Addendum #2

Contract ID: Q Drive South
Location: Athens West of 1.5 Mile Rd.
Description: Gravel road to HMA surface

Q Drive South Proposed
Cross Section

Typical Section
Organic Areas

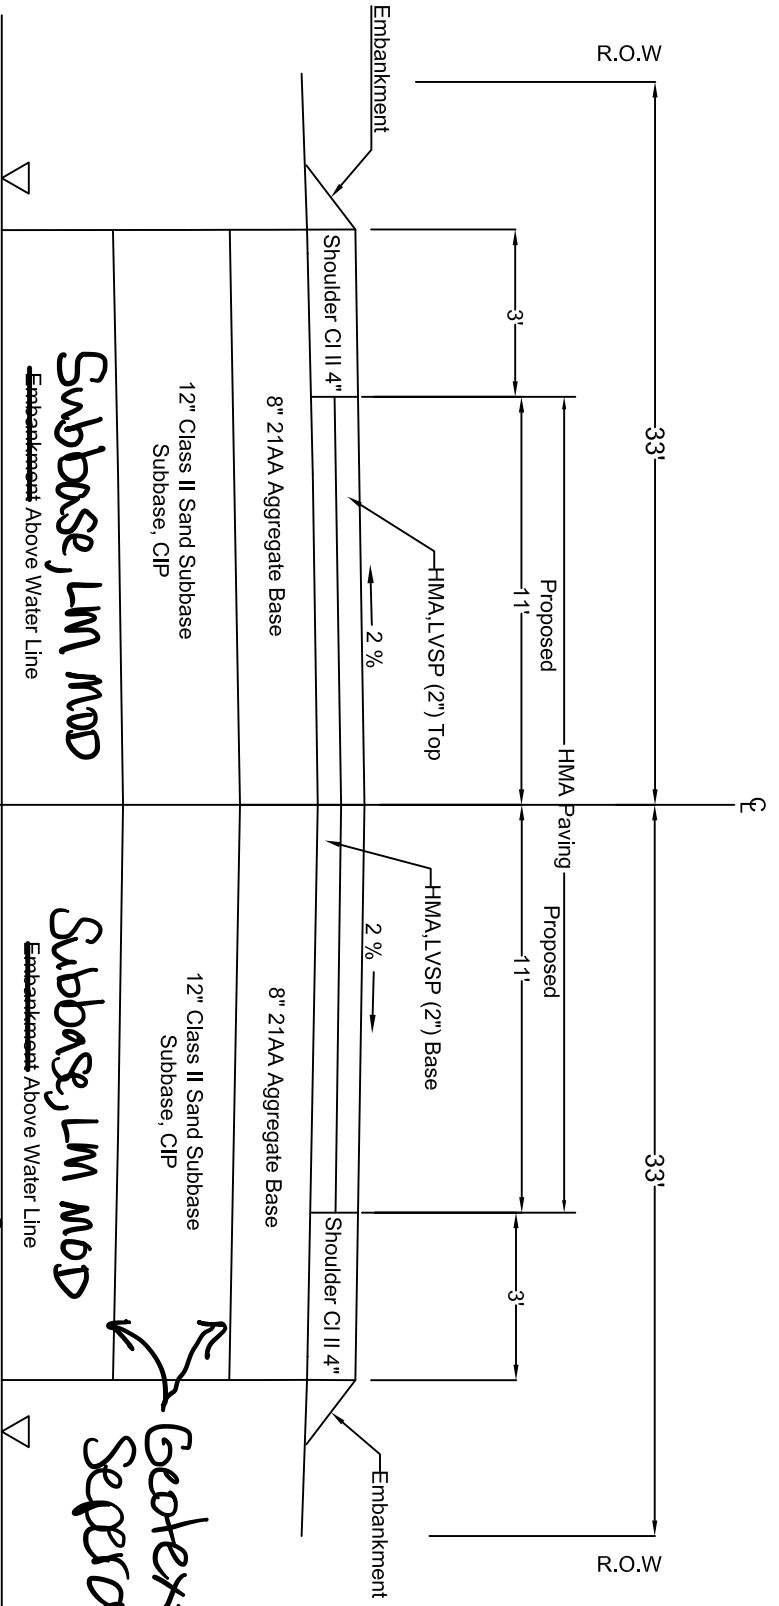
- A2. Subbase, LM MOD is being used for the 1x3 material. See special provision on P. 6 of this addendum.
- Q3. The cross section provided for organic areas on page 26 does not show geotextile separator, geotextile stabilization and blast furnace slag as described in the Project Log as Areas A, B & C. The cross section shows 12" subbase and embankment below the subbase. I assume that per the Project Log descriptions that the embankment is actually subbase or blast furnace slag? How is the blast furnace slag paid for?

- Q6. 3000 cy of Subbase, LM, MOD is setup in the job. It is referenced in the project log as part of the "Organic" road section but doesn't show up on the typical section for the "Organic" cross section. Can you please clarify what this is for and provide a special provision for it?

- A3. An updated cross section is on P. 7 of this addendum.
- Q4. Are you eliminating the detour route on this project? If so, why? You can dig out 7' deep of roadway and still maintain a lane of traffic.

- A6. An updated cross section is on P. 7 of this addendum.

Please see the log for specific materials for each excavation, Rest area
